Groundwater Transfer Review Summary Form

Transfer/PA # T- 14124

Ground Water Review Form:

Application: T-14124

Transfer Review Map

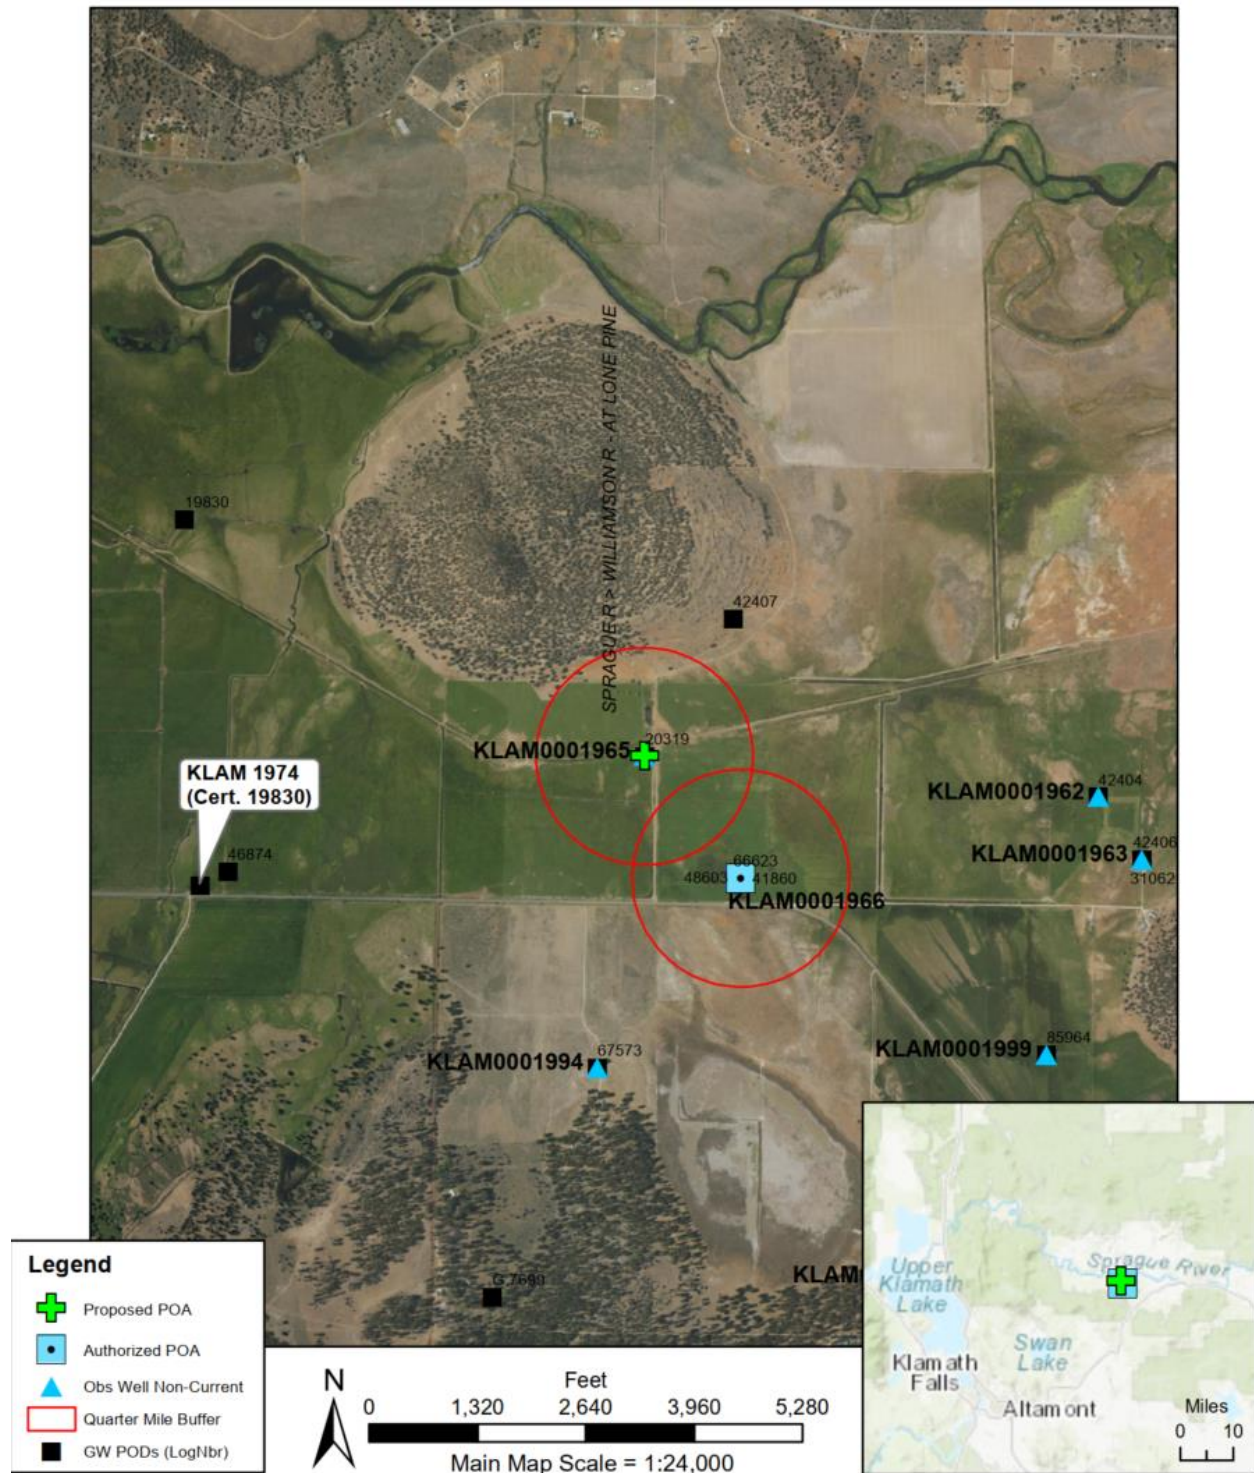
4. a) Will this proposed change, at its maximum allowed rate of use, likely result in an increase in interference with **another ground water right**?
☒ Yes ☐ No Comments: The closest POA associated with a senior water right is **KLAM 1974** under **Certificate 19830**. Proposed POA **KLAM 1965** is ~5,600 feet from **KLAM 1974** compared to ~6,500 feet from the authorized POA **KLAM 1966**. The reduced intervening distance will likely cause an increase in interference with **KLAM 1974** which also sources water from the volcanic and sedimentary rocks of the Winema Volcanic Field.

- b) If yes, would this proposed change, at its maximum allowed rate of use, likely result in another groundwater right not receiving the water to which it is legally entitled?
☐ Yes ☒ No If yes, explain: 1.26 csf of use is already authorized from **KLAM 1965** under **Certificate 20319**. An additional rate of 0.564 cfs is proposed under this current temporary transfer bringing the total rate of appropriation from **KLAM 1965** to 1.82 cfs between March 1 and October 31. Estimated drawdown was calculated using the Theis (1935) solution for drawdown in a confined aquifer and representative literature aquifer parameters (Gannett et. al., 2007) at this combined rate (see attached Theis Drawdown Analysis). Predicted drawdown observed at 5,600 feet is estimated to be less than 5 feet. Therefore, at the proposed combined rate of 1.82 cfs, it is unlikely that another groundwater right will not receive the water that it is legally entitled.

5. a) Will this proposed change, at its maximum allowed rate of use, likely result in an increase in interference with **another surface water source**?
☒ Yes ☐ No Comments: The proposed POA **KLAM 1965** is ~4,900 feet south of the Sprague River, whereas authorized POA **KLAM 1966** is ~6,400 feet south of the Sprague River. The reduced intervening distance is likely to increase interference with the Sprague River.

- b) If yes, at its maximum allowed rate of use, what is the expected change in degree of interference with any **surface water sources** resulting from the proposed change?
Stream: Sprague River ☒ Minimal ☐ Significant
Stream: _____ ☐ Minimal ☐ Significant
Provide context for minimal/significant impact: The reduced intervening distance between the proposed POA **KLAM 1965** and the Sprague River will likely cause an overall increase in interference with the Sprague River. However, the presence of approximately ~150 to 200 feet of lower permeability late Tertiary sedimentary rocks above the more transmissive "basalts" likely reduces the efficiency of the hydraulic connection of groundwater to surface water. A less efficient hydraulic connection to a surface water source would buffer the timing of stream depletion impacts and spread them more evenly throughout the year. Additionally, the presence of a rhyolitic dome directly north of the proposed POA is likely to further reduce the efficiency of the hydraulic connection. Due to the expected less efficient hydraulic connection with the Sprague River at this location and relatively small reduction in distance compared to the already authorized POA, the expected change in degree of interference is likely minimal.
